LICENSEE: System Energy Resources, Inc. (SERI)

FACILITY: Grand Gulf Nuclear Station (GGNS), Unit 1

SUBJECT: SUMMARY OF FEBRUARY 10 AND 11, 1988 MEETING
REGARDING LICENSING ACTIONS

ATTACHMENT 3
 10 MNCR 0015-28
 PAGE 1 OF 2

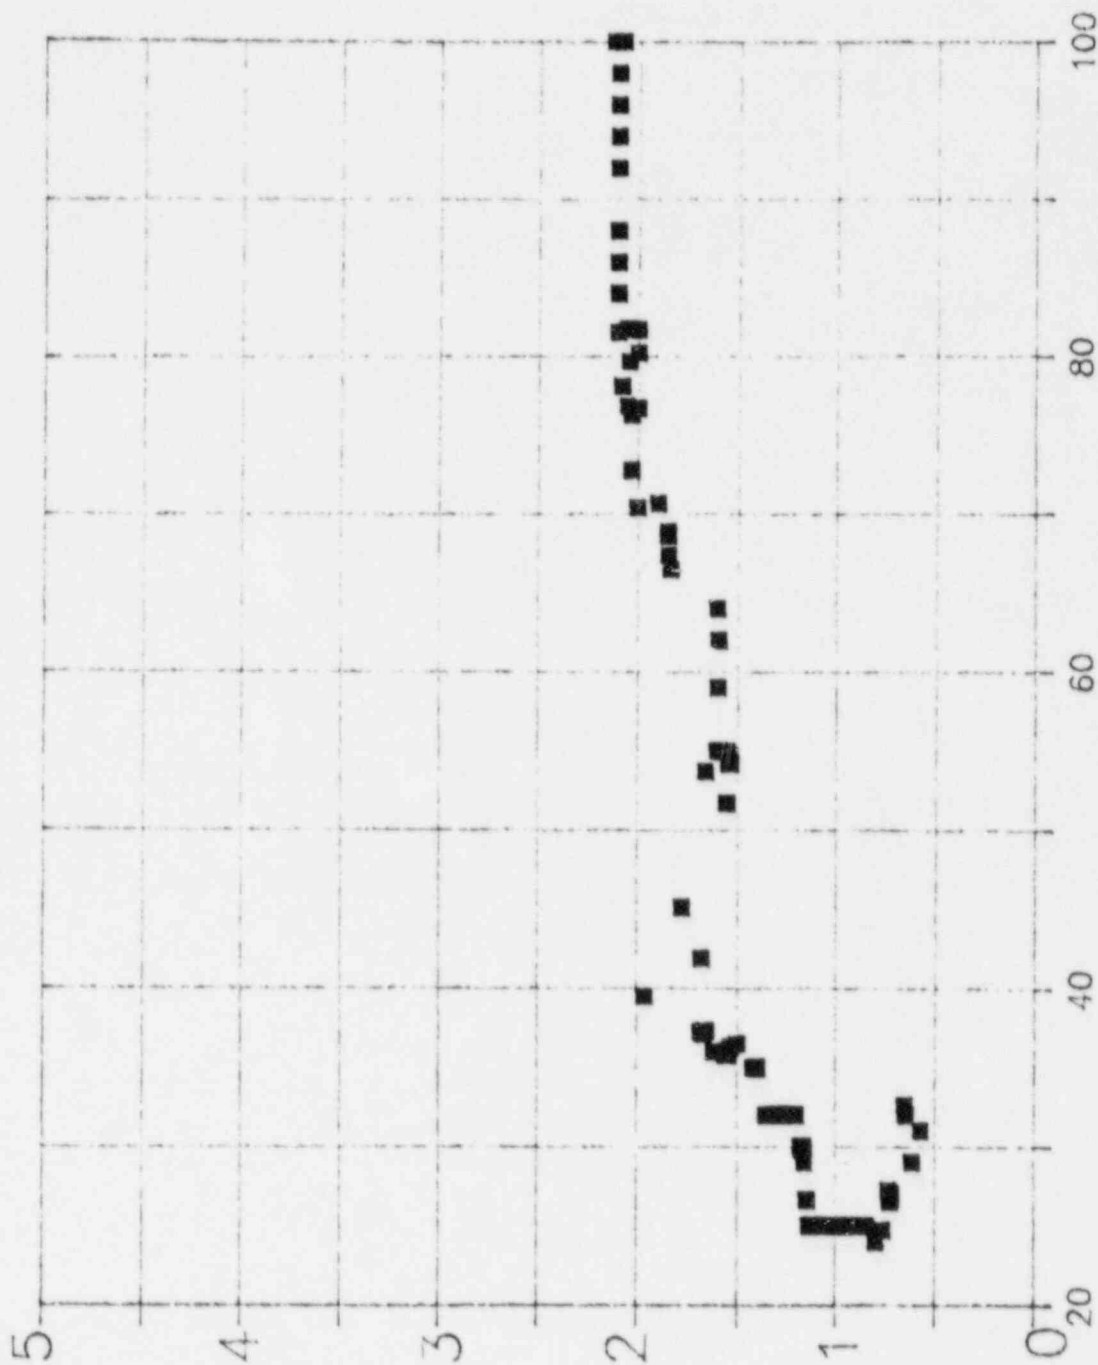
NPE has evaluated the differential pressure (dP) data taken by Plant Staff I&C during two consecutive startups for the three core spray line break instrument channels. The data taken for these two startups indicate that there is a range of normal dP for which the instruments must be capable of detecting a line break. The two startups are bounded by a dP range of 1.5 PSID to 2.1 PSID for the LPCS/LPCI-A channel above 80% power and 90% core flow (See Attachment 3). Consequently, the normal dP referred to in the Technical Specification section 4.5.1.c.2.b) is from 1.5 to 2.1 PSID, inclusively. The LPCI-B/LPCI-C dP, on the other hand, is constant at .25 PSID and this the normal dP referred to in the Technical Specifications.

In order to prevent conflict with the existing Technical Specification requirements, the actual setpoints to be used will be based on the above bounding normal dP values and the requirement that the setpoints be 1.2 +/- .1 PSID change from the normal indicated dP. The actual setpoints and tolerances to be used are summarized below.
